Access Compliance Report

Public Rights-of-Way

Intersection ID: 14620	Main Street: EUCLID_AV	Cross Street: MCDONALD_AV	Location:	N
ADA ID: 2EAF4D6FE763	Ramp Type: Directional1	Initial Pass/Fail: Fail	Overall Compliance: No	Severity Score: 1.25
Codes/Mitigation Info/Possible Solution		Field Measurements/Component Compliance

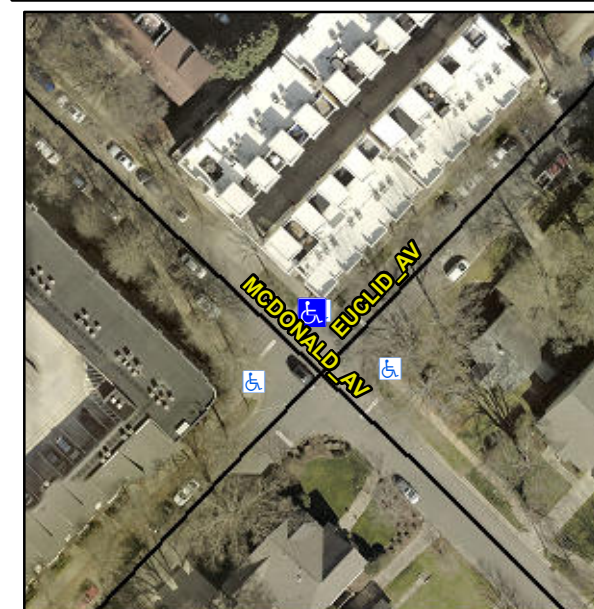
DWS LIP 1.0"

R304.5.3

Compliance	Description	Data	Compliance	Description	Data
N/A	Ramp Length (in)	32.0	N/A	Grade Break?	N/A
Yes	Ramp Width (in)	73.0	N/A	Grade Break Slope (%)	0.0
Yes	Ramp Slope (%)	7.3	N/A	Grade Break XSlope (%)	0.0
No	Ramp XSlope (%)	3.7			
N/A	Flare Type LT	N/A	N/A	Flare Type RT	N/A
N/A	Flare Slope LT (%)	N/A	N/A	Flare Slope RT (%)	0.0
N/A	Flare Traversable LT?	N/A	N/A	Flare Traversable RT?	N/A
N/A	Landing Length (in)	0.0	N/A	DWS Provided?	N/A
N/A	Landing Width (in)	0.0	N/A	DWS Contrast?	N/A
N/A	Landing Slope (%)	0.0	N/A	DWS Length (in)	N/A
N/A	Landing X Slope (%)	0.0	N/A	DWS Full Width?	N/A
N/A	Landing Curb? (Y/N)	N/A	N/A	DWS Offset LT (in)	N/A
N/A	Shared Landing?	N/A	N/A	DWS Offset RT (in)	N/A
N/A	Gutter Ponding?	0.0	N/A	Gutter Slope (%)	N/A
N/A	Gutter Lip Ht (in)	0.0	N/A	Gutter X Slope (%)	N/A
N/A	Painted X Walk1?	No		Road Slope (%)	4.8
	X Walk 1 Direction	To SW		Road X Slope (%)	0.8
	X Walk 1 Width (in)	N/A		Clear Space?	N/A

Remove & Replace Entire Ramp.
